Docket Number:	26-SPPE-02
Project Title:	Silver Creek Back-up Generating Facility (SFBGF)
TN #:	272834
Document Title:	Prologis SPPE Application Silver Creek Backup Generating Facility - App C Part I of II
Description:	N/A
Filer:	Scott Galati
Organization:	DayZenLLC
Submitter Role:	Applicant Representative
Submission Date:	9/18/2026 9:12:51 AM
Docketed Date:	9/18/2026

Caterpillar 3516E Specifications

CARTER POWER SYSTEMS

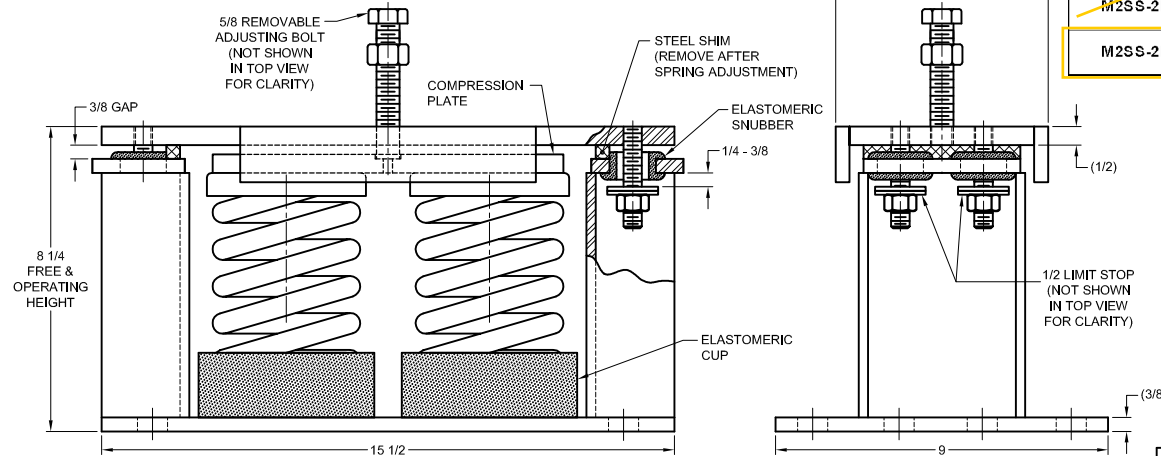
See comments on BOM. Provide to Arch/struct for review.
